**STATE OF CONNECTICUT  
CONNECTICUT SITING COUNCIL**

<b>Petition of BNE Energy Inc. for a</b>	<b>:</b>	<b>Petition No. 983</b>
<b>Declaratory Ruling for the Location,</b>	<b>:</b>	
<b>Construction and Operation of a 4.8 MW</b>	<b>:</b>	
<b>Wind Renewable Generating Project on</b>	<b>:</b>	
<b>Flagg Hill Road in Colebrook,</b>	<b>:</b>	
<b>Connecticut (“Wind Colebrook South”)</b>	<b>:</b>	<b>December 4, 2013</b>

**OBJECTION TO BNE ENERGY INC.’S  
DEVELOPMENT AND MANAGEMENT PLAN MODIFICATION**

**Table 6. Monthly site measured mean wind speeds in m/s at 60 m – C5 (Tower)**

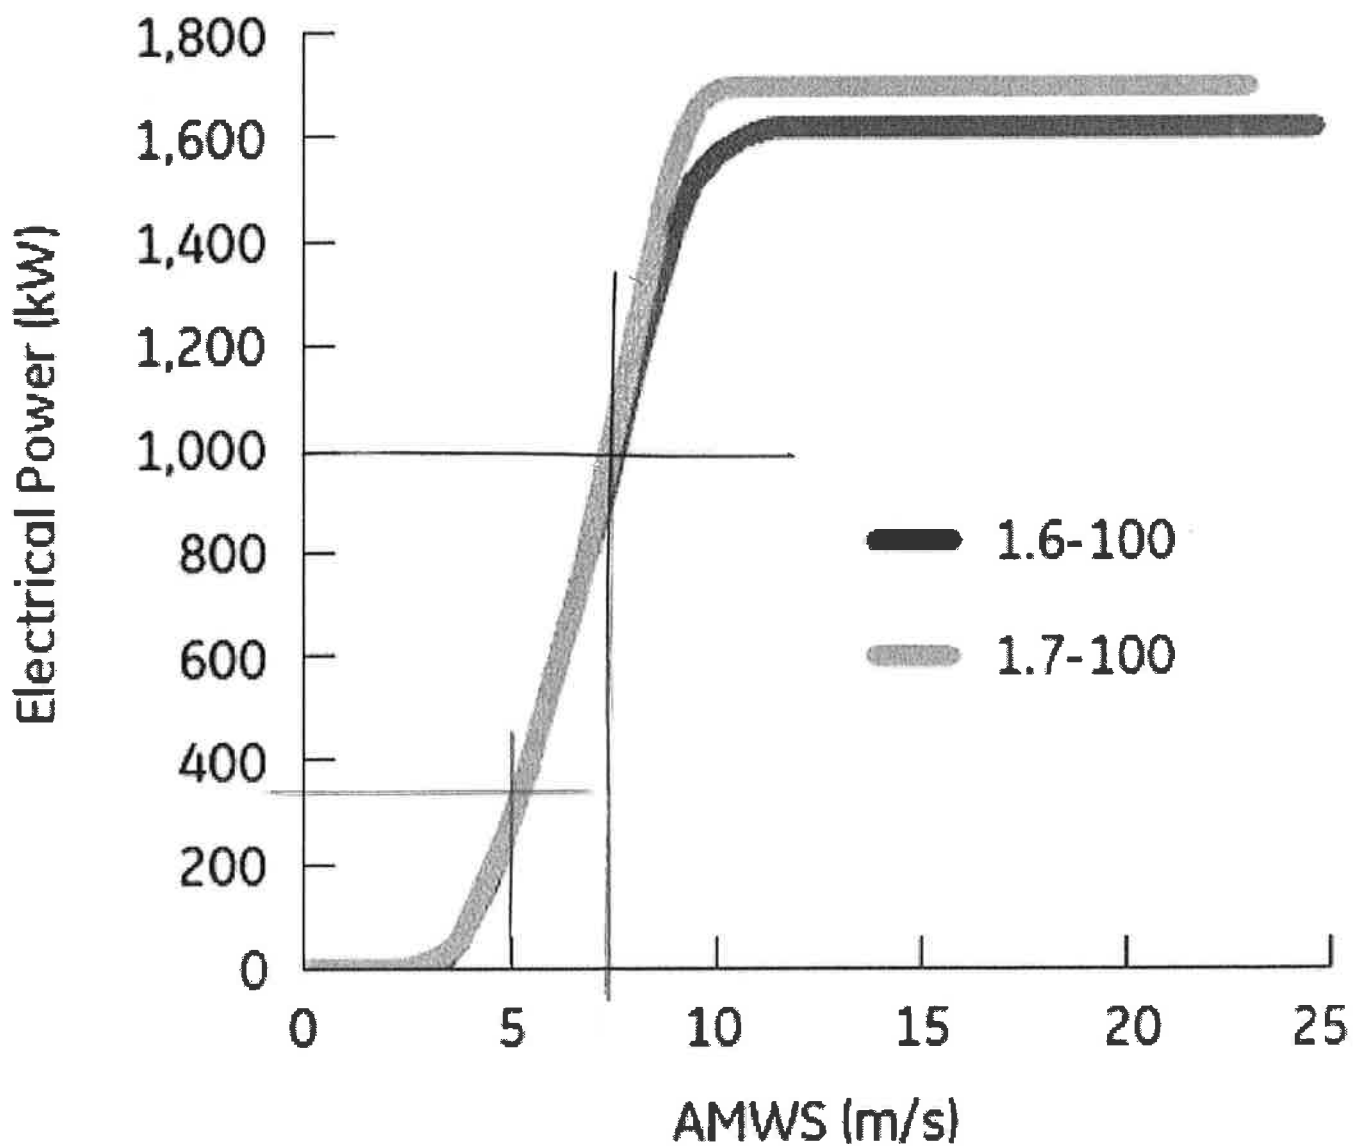
Based on the information provided by BNE, the GE 1.6 MW turbines would actually produce more electricity than the GE 2.85-103 turbines at the Flagg Hill Road site with the prevailing wind conditions. BNE’s wind study found that the average monthly wind speed on this site, over a 14-month period, was 5.86 m/s, with no month exceeding 7.78 m/s. (See BNE Wind Assessment, attached to Exhibit M to BNE’s Petition for Declaratory Ruling, filed December 6, 2010, at 12 (relevant excerpts are attached hereto as Exhibit 1).) In the summer months, when the need for electricity is generally greatest, the average wind speed was 4.51 m/s. (Id.)

# **EXHIBIT 2**

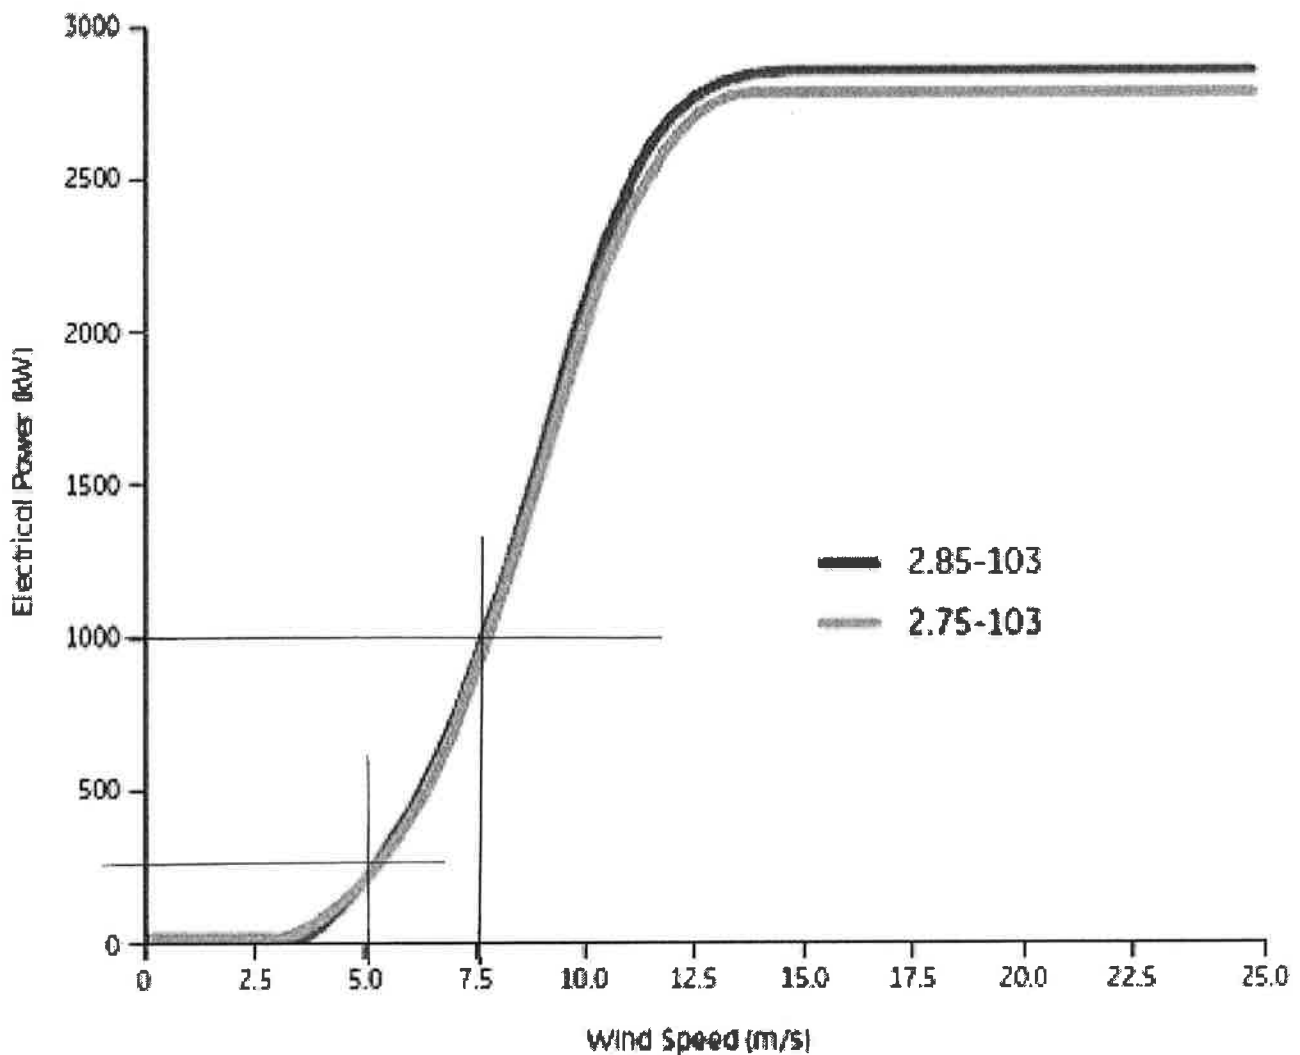
According to GE power curve graphs provided by BNE, at wind speeds of 7.5 m/s, both the 1.6-100<sup>3</sup> and the 2.85-103 turbines can be expected to produce 1000 kW (or 1 MW) of electricity. (See Power Curves, attached hereto as Exhibit 2.<sup>4</sup>) At wind speeds of 5 m/s, which, as noted above, are not uncommon in Colebrook, the graphs indicate that the 1.6-100 turbines will produce approximately 330 kW of electricity, while the 2.85-103 turbines will produce only approximately 260 kW. (See id.)
